3801 Stone Way N Seattle, WA 98103

*Supplemental Package
Design Recommendation Meeting
DPD #3014111
10.21.2013*

The developer and design team, working closely with the DPD, have made the specific revisions described and illustrated within this packet, in response to the Design Recommendations from the August 19th, 2013 DRB Meeting.

Revised Residential Entry

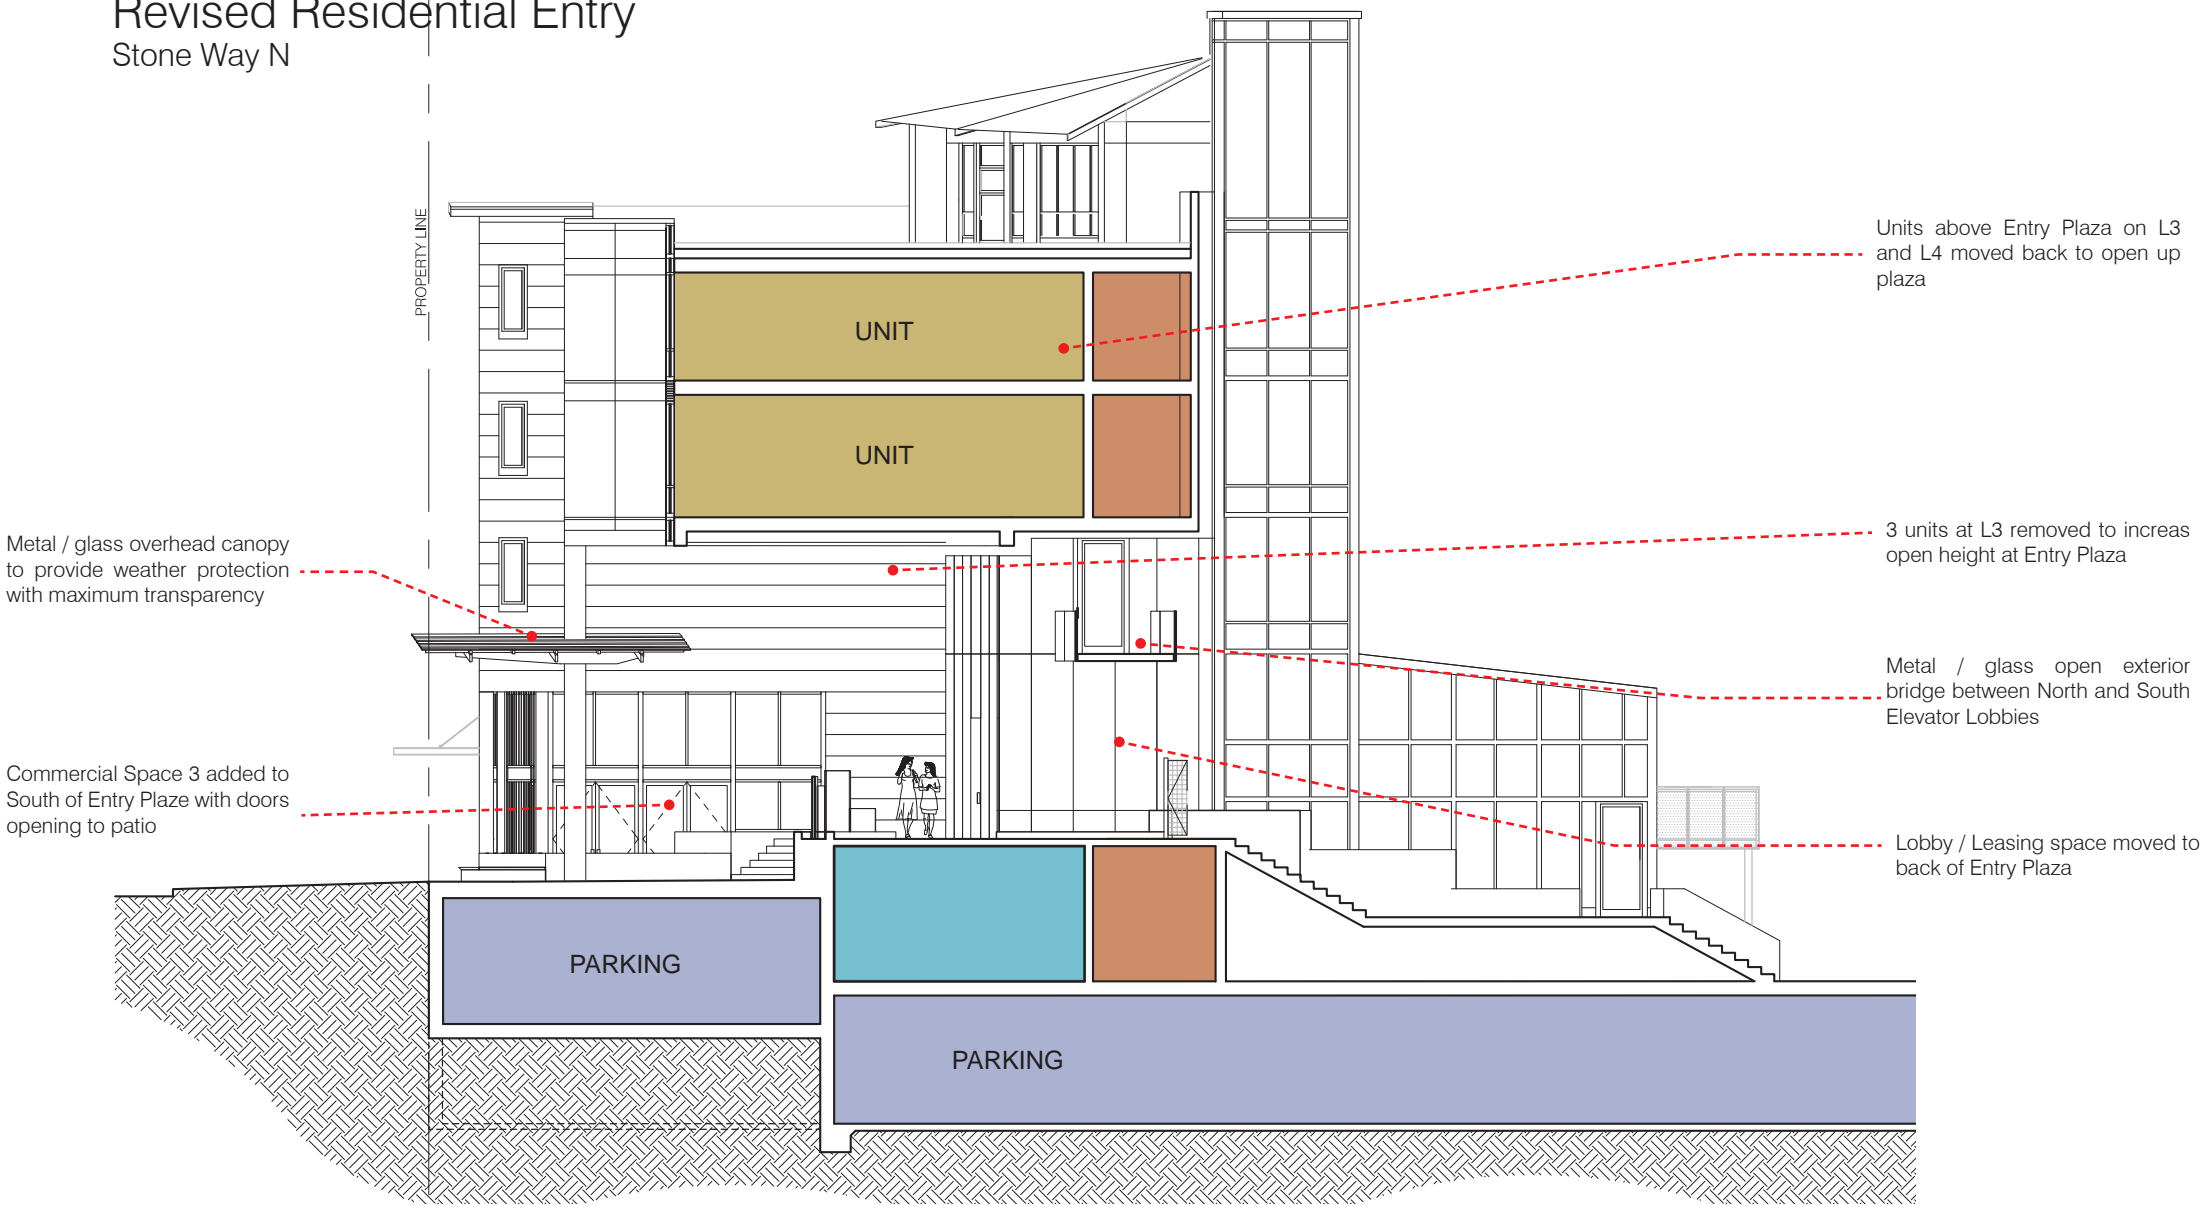
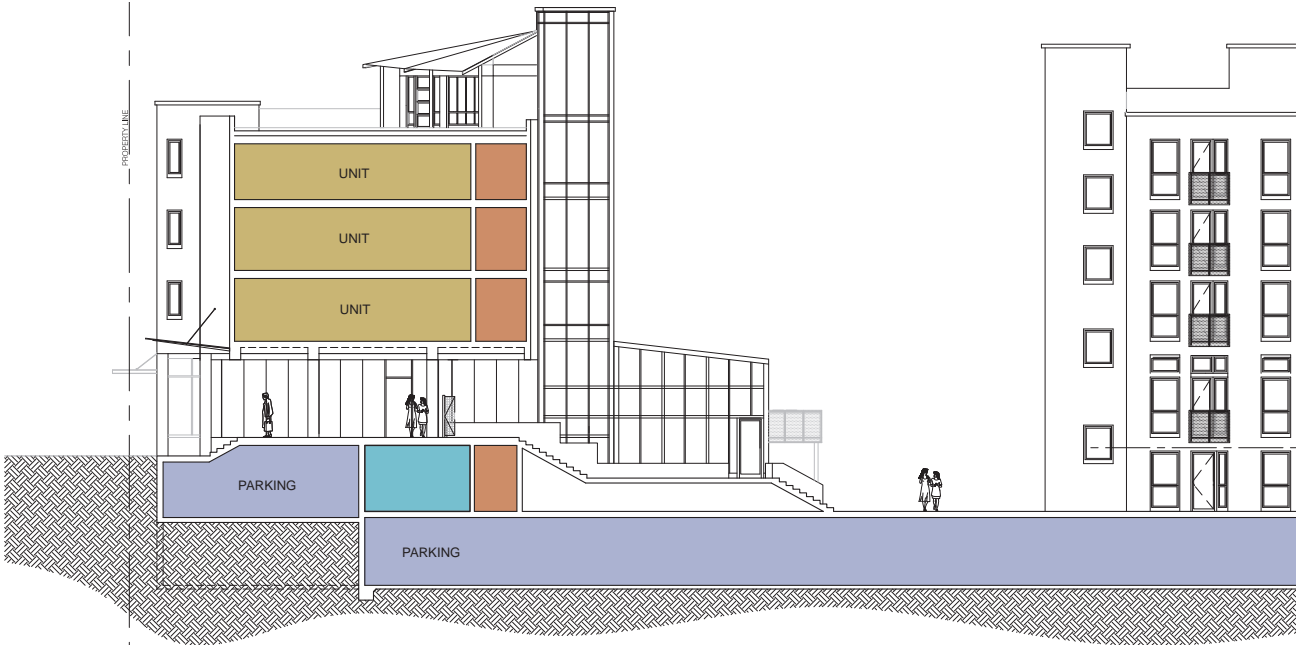
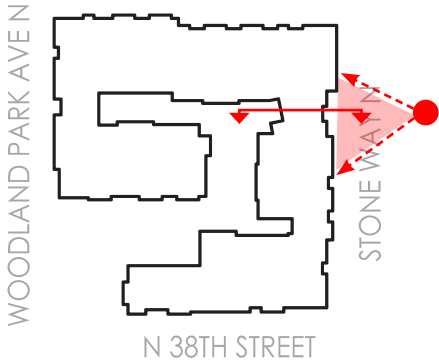
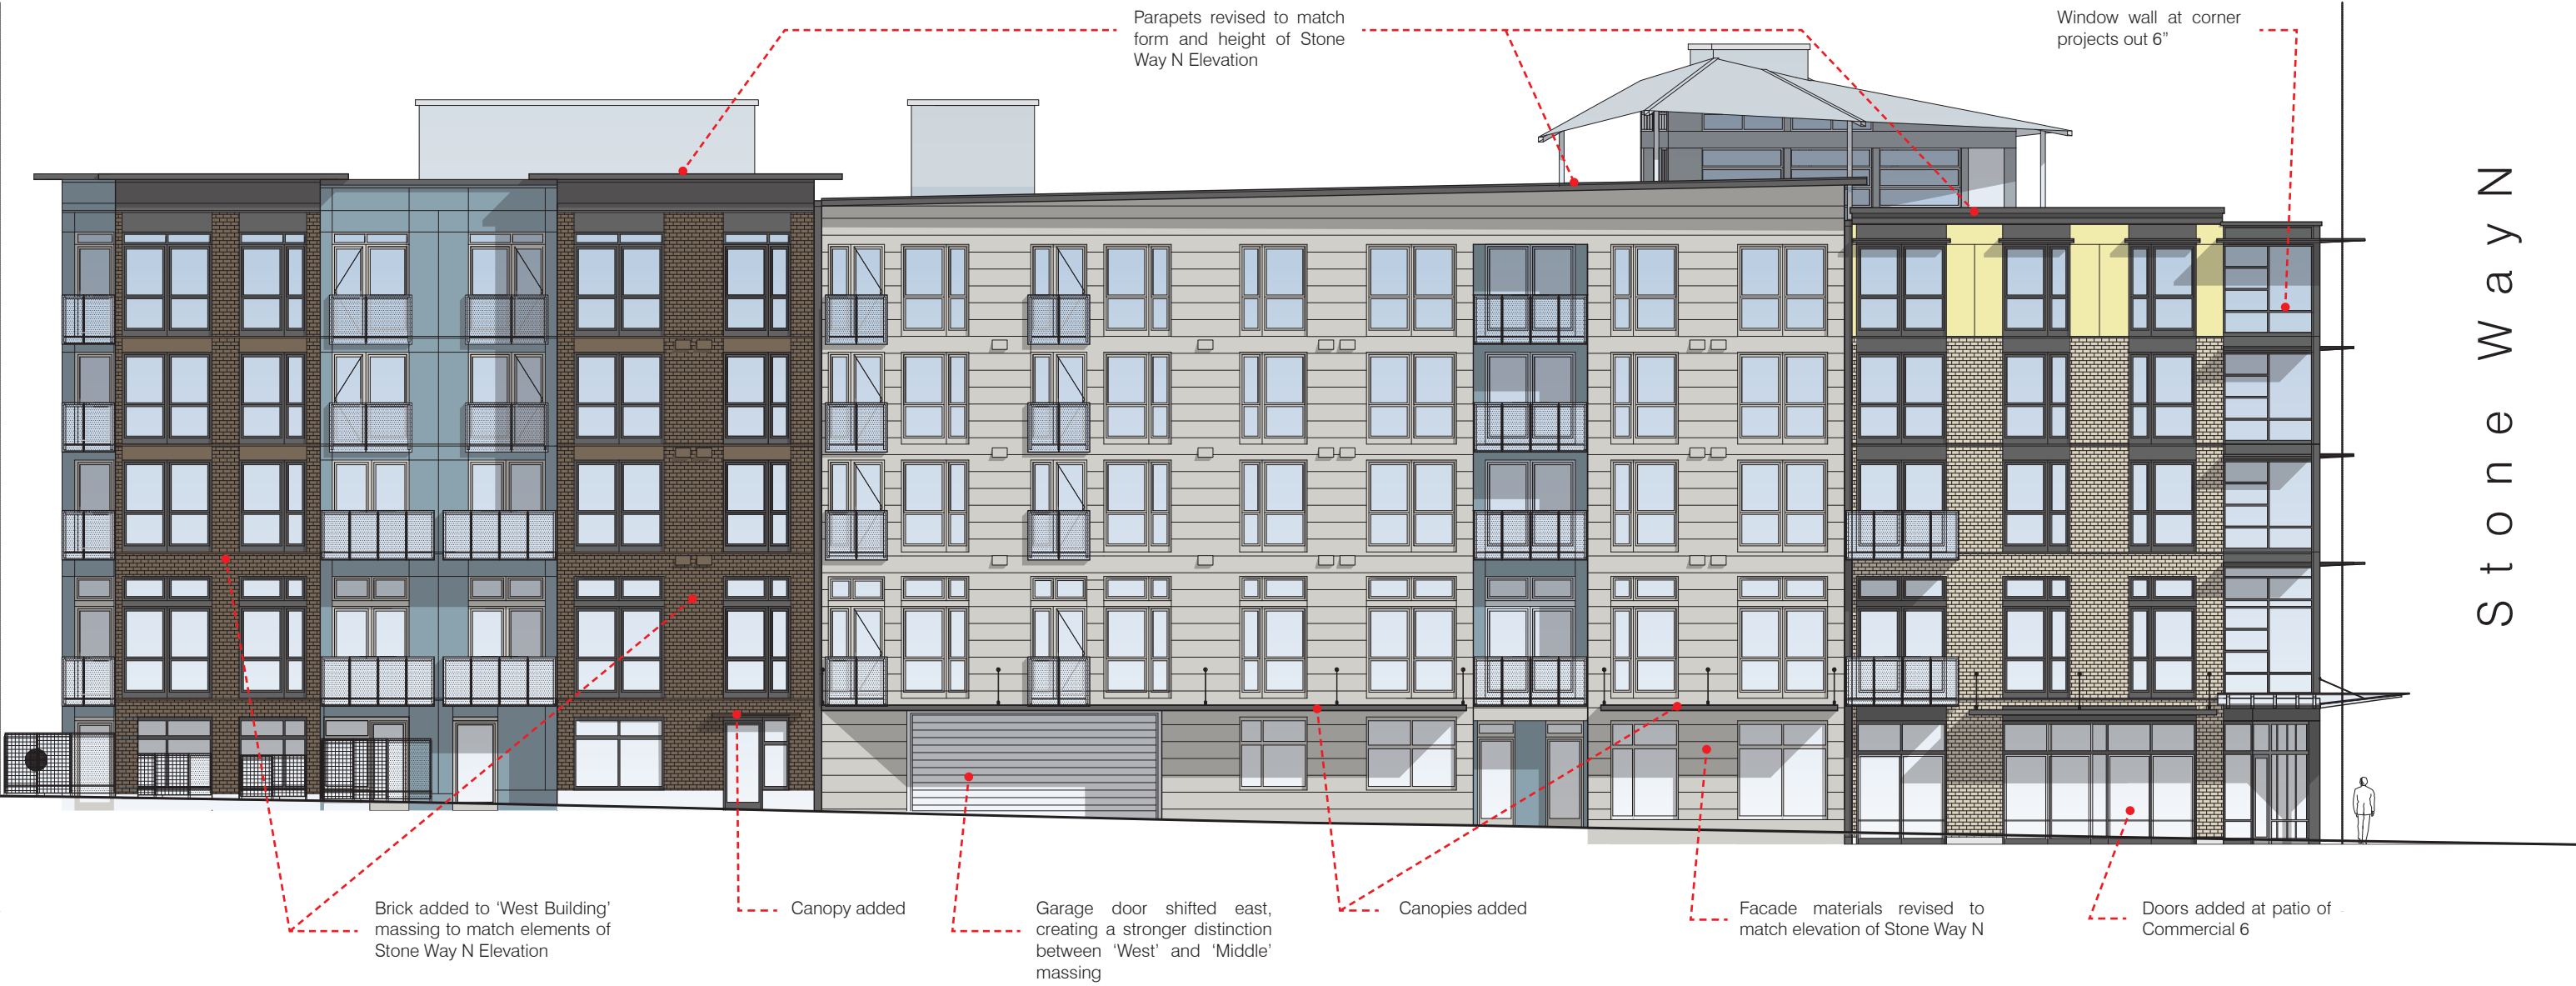
“...Enlarge the portal by creating a two-story opening that befits a façade length of nearly 300 feet. Rearrange the open space to emphasize gathering over passage, this space ought to complement commercial spaces that will flank it. See the discussion in guidance A-4 to relocate the leasing office for additional commercial space to adjoin the plaza. The south wall of the north commercial space ought to have glazing visually connecting to the plaza. These changes will create a space for people to occupy and that will supplement the adjacent commercial uses.”

Parapets sloped and angle out

Leasing / Lobby moved to rear of entry plaza

Entry portal widened and three units at L3 removed to increase height

Leasing area changed to commercial space

Patio with doors at Commercial 3

Commercial at north and south of entry open to entry plaza

Doors and patio added at Commercial 2

PREVIOUS SOUTH ELEVATION | 08.19.2013

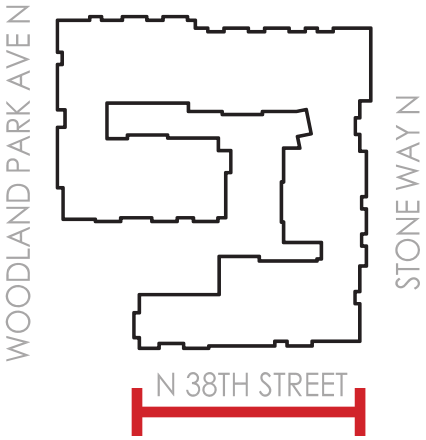
"...The vertical corner bay of windows should assume a different plane than adjacent facades on East and South Elevations"
In response to Design Guideline A-10, Corner Lots
(Design Recommendation, 10/19/2013)

PREVIOUS WEST ELEVATION | 08.19.2013

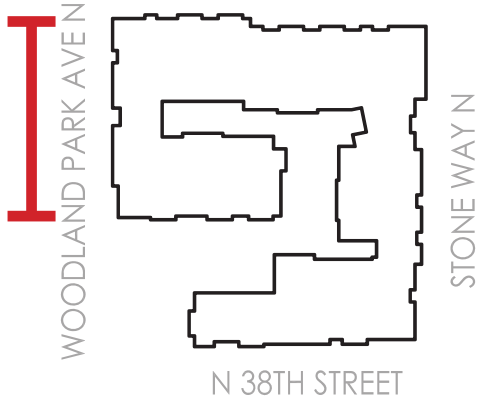
"...The Board conveyed its interest in ensuring maximum transparent along Stone Way N and N 38th Street."
In response to Design Guideline D-11,
Commercial Transparency
(Design Recommendation, 10/19/2013)

Revised Roof Plan
Parapet Design

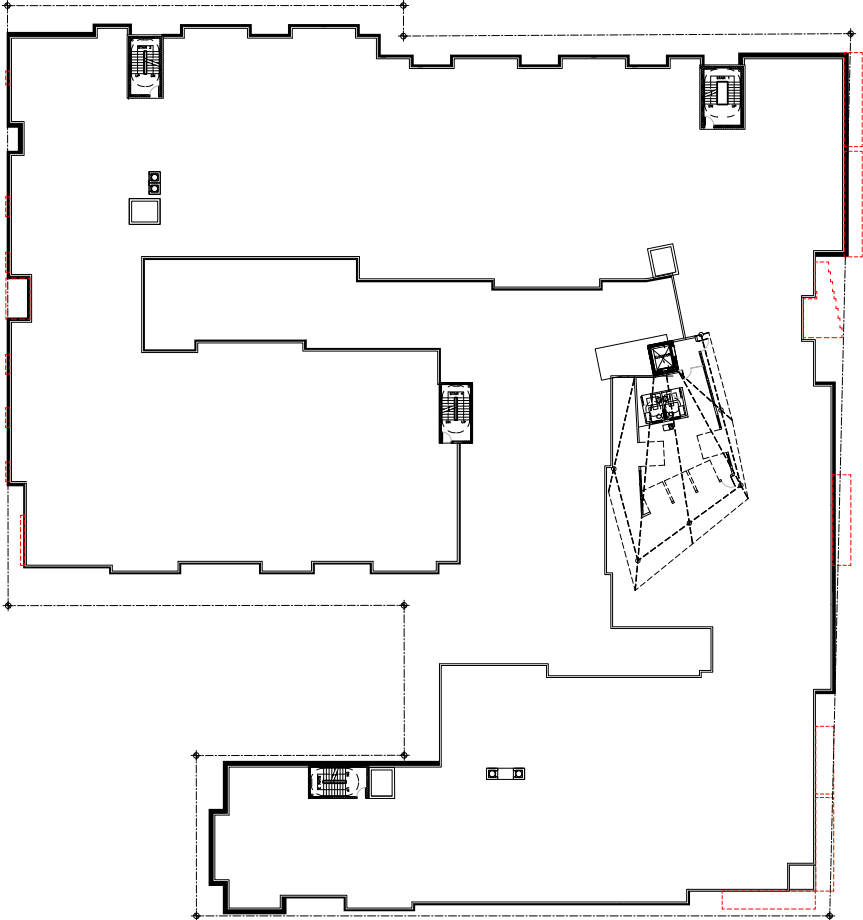
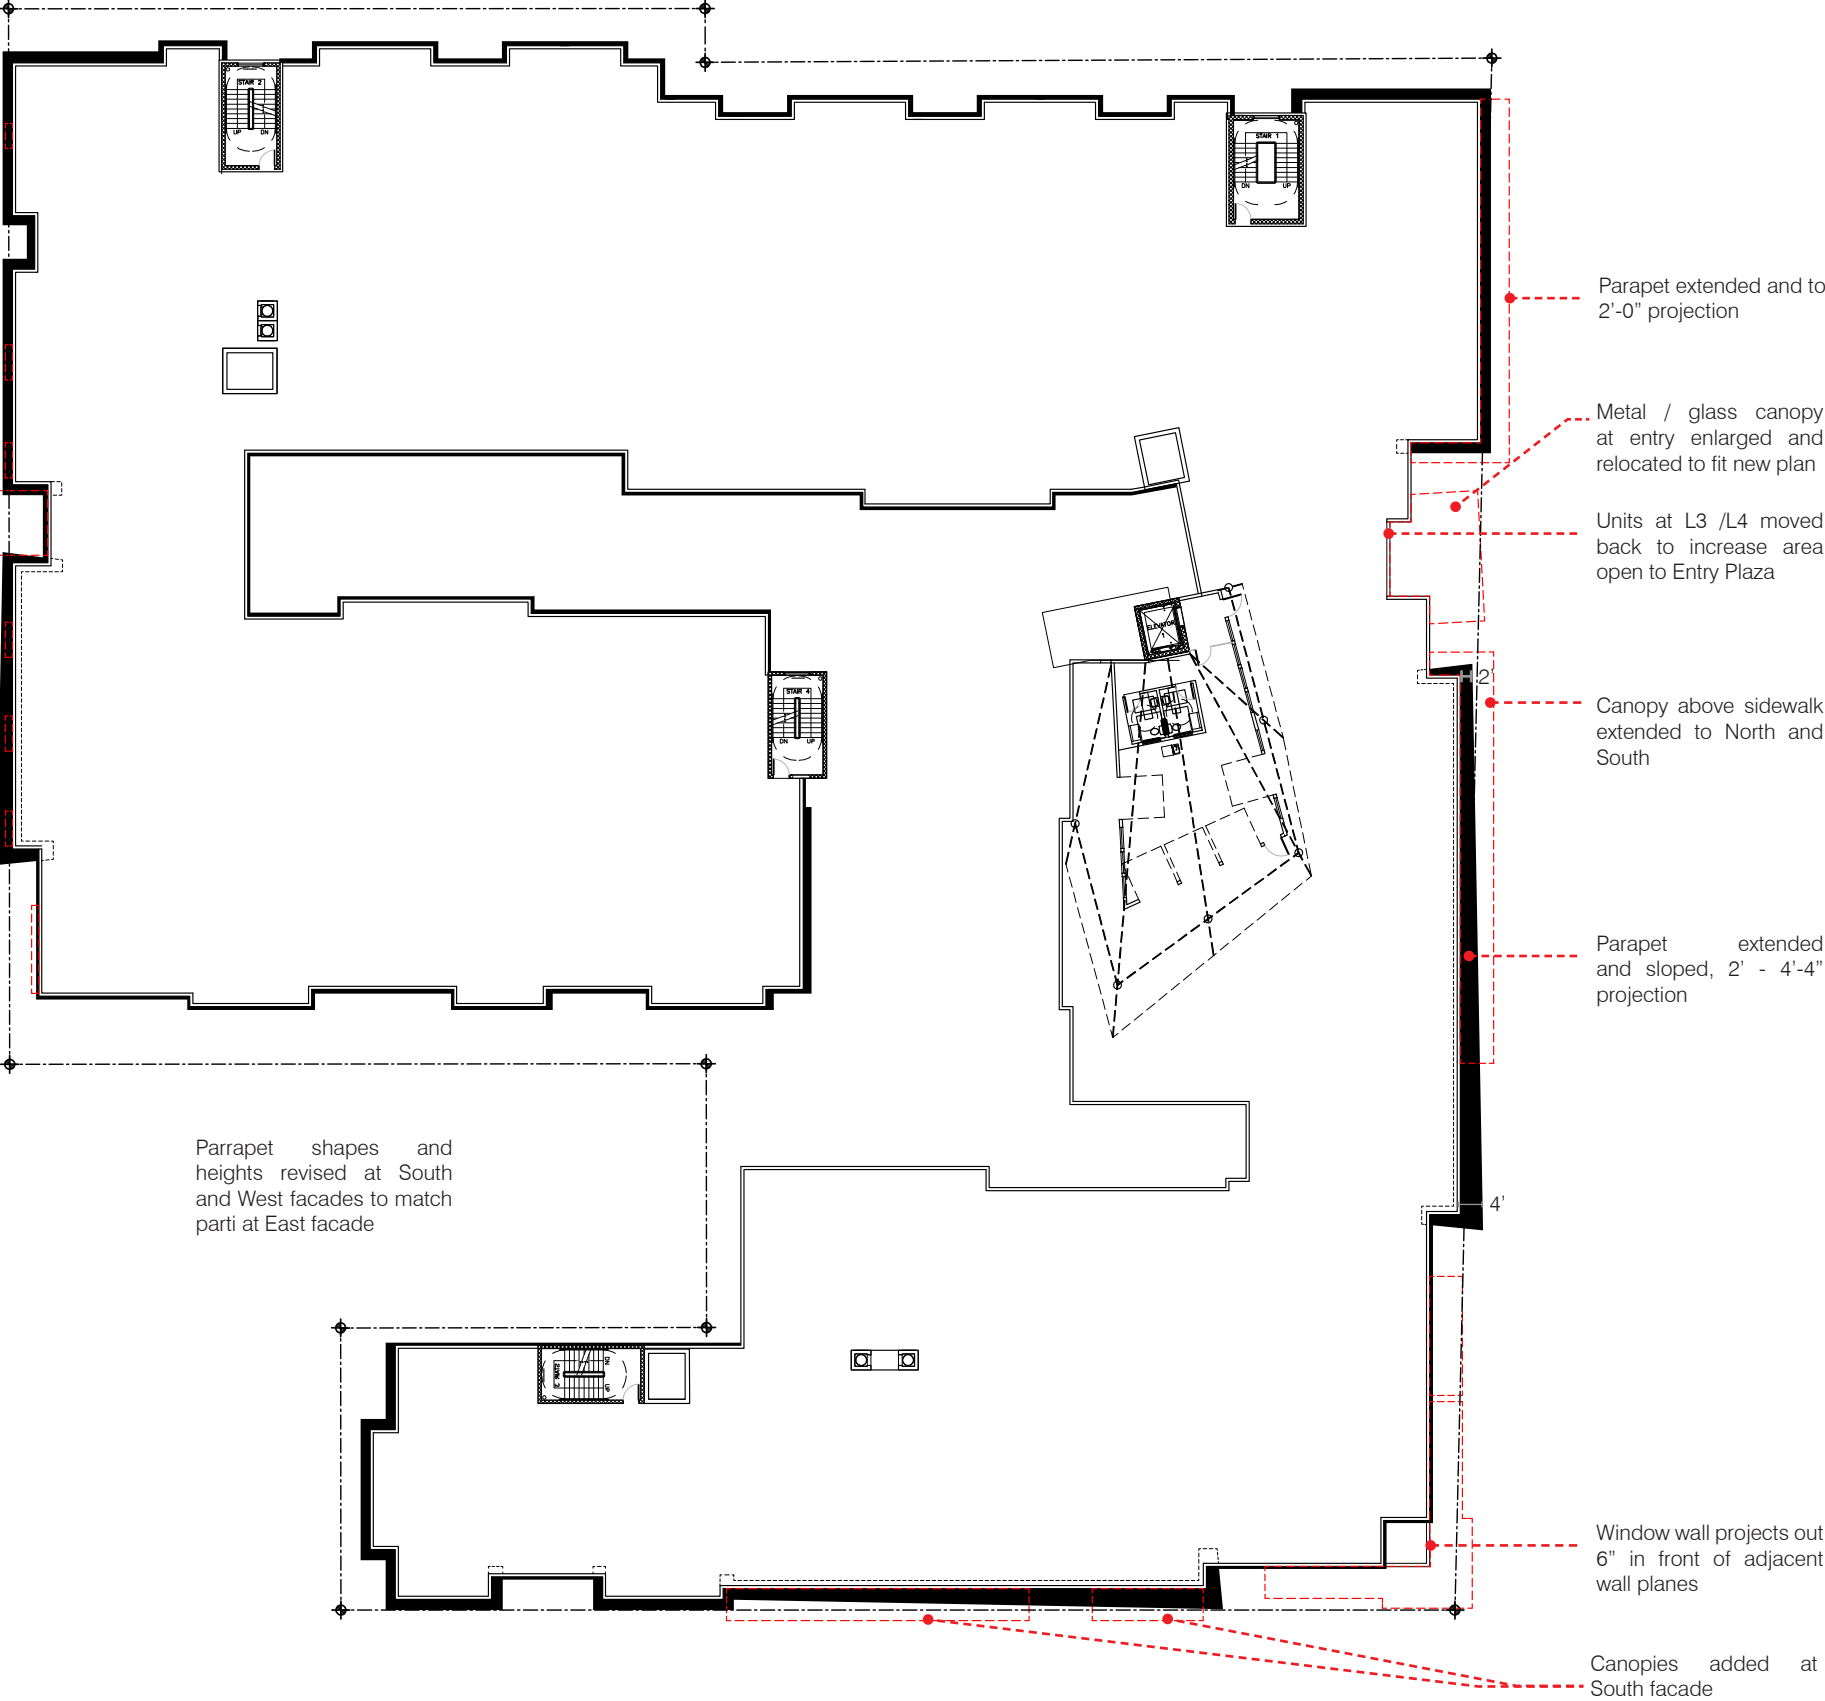
"...The roofline on Woodland Park Ave N must step down in plane as it follow the descent of the terrain."
